EVALUATION OF EMERGENCY RESPONSE FACILITIES FOR  
INDIAN POINT - UNIT 2

October 1981

Pacific Northwest Laboratory  
Richland, Washington 99352

## Indian Point 2

FIGURE 2.1

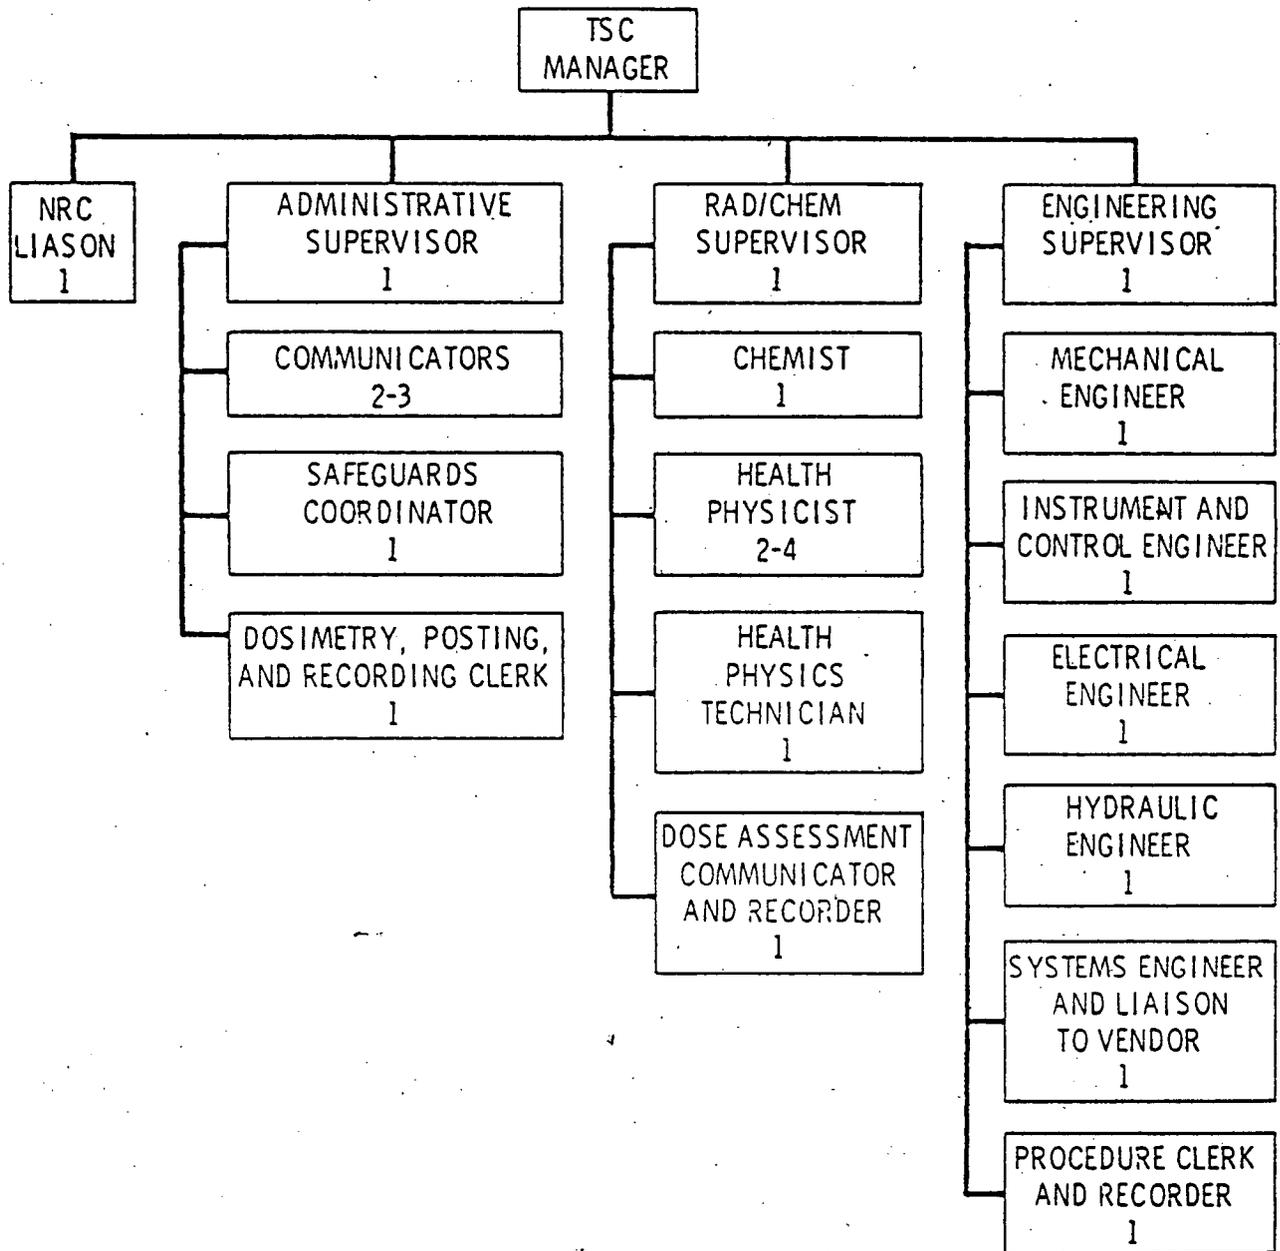
<p>Describe the organization of the work stations. Are they organized according to Figure 2.1?</p>	<p>Subject not addressed.</p>
<p>Describe how the workspaces are designed to control traffic and noise (mechanical and conversational).</p>	<p>Subject not addressed.</p>
<p>b. Space for TSC data system equipment needed to transmit data to other locations.</p>	<p>Inadequate response. Licensee states this will be true but provided no information for evaluation.</p>
<p>Where is the data displayed?</p>	<p>Subject not addressed.</p>
<p>Show how layouts of displays are coordinated with working space layouts.</p>	<p>Subject not addressed.</p>

- b. Consist of sufficient technical personnel needed to support the control room including individuals who can handle situations involving operations, maintenance, administration, security, Rad/chem, and communications (Figure 2.1 is an example only).

FIGURE 5.2

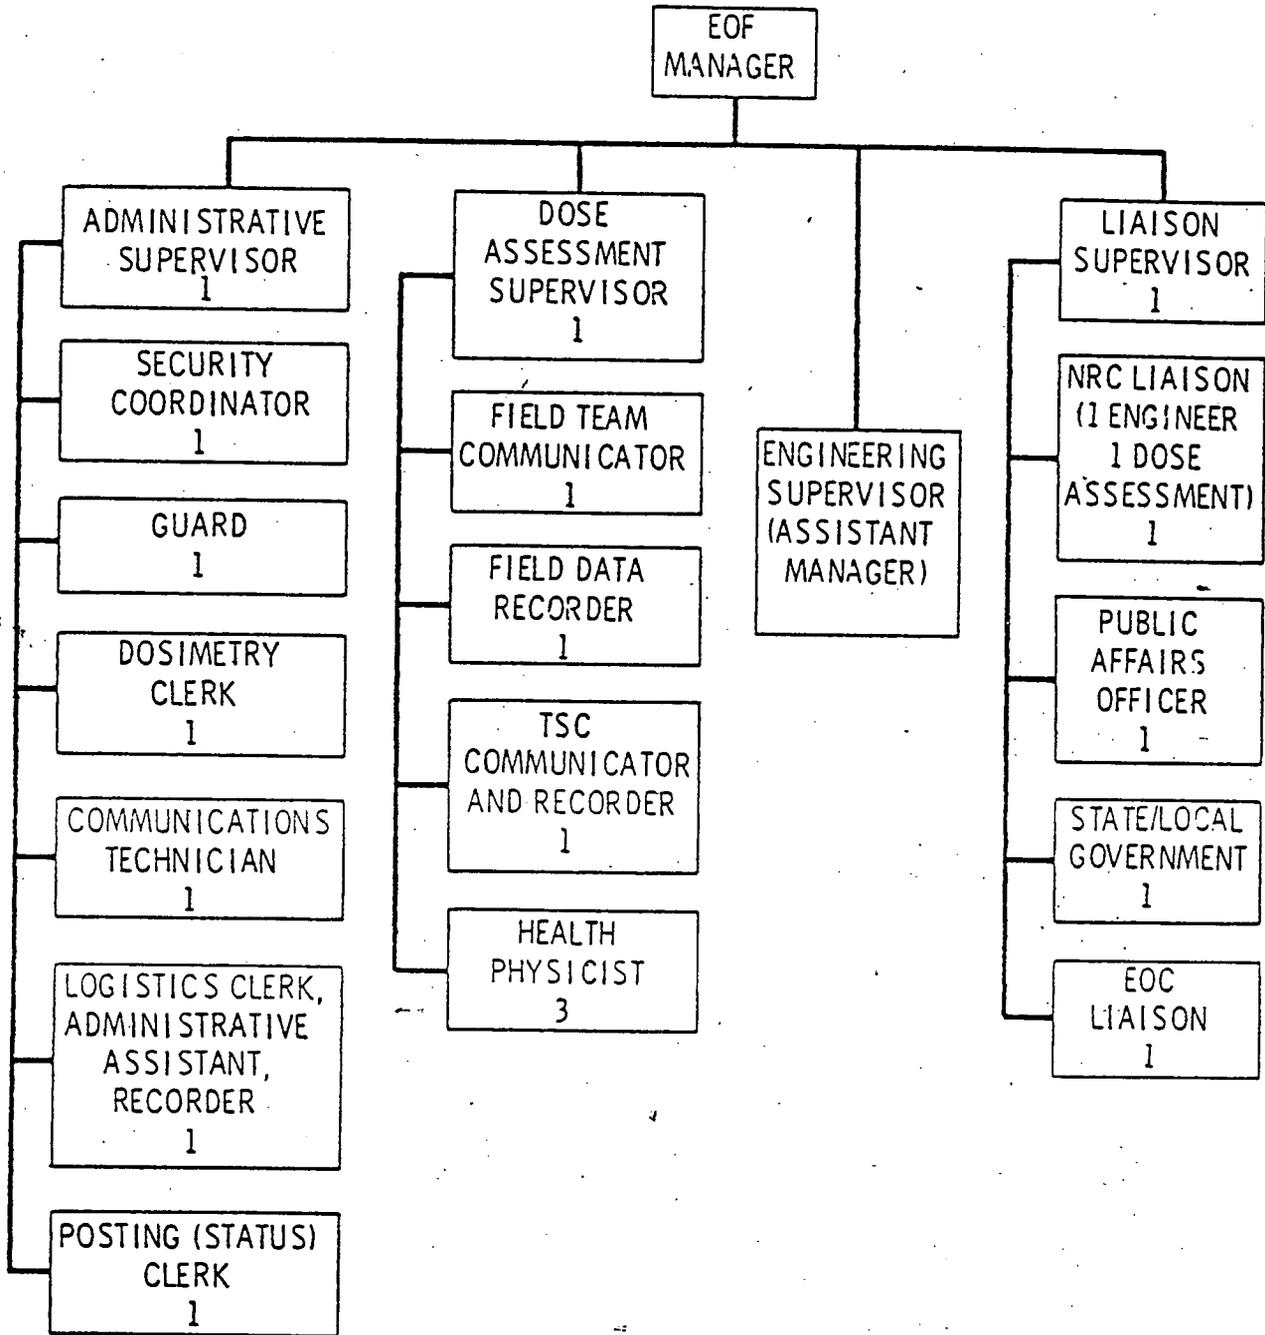
| Describe the organizations of the work stations. Are they organized according to Figure 5.2?  | Subject not addressed.   |
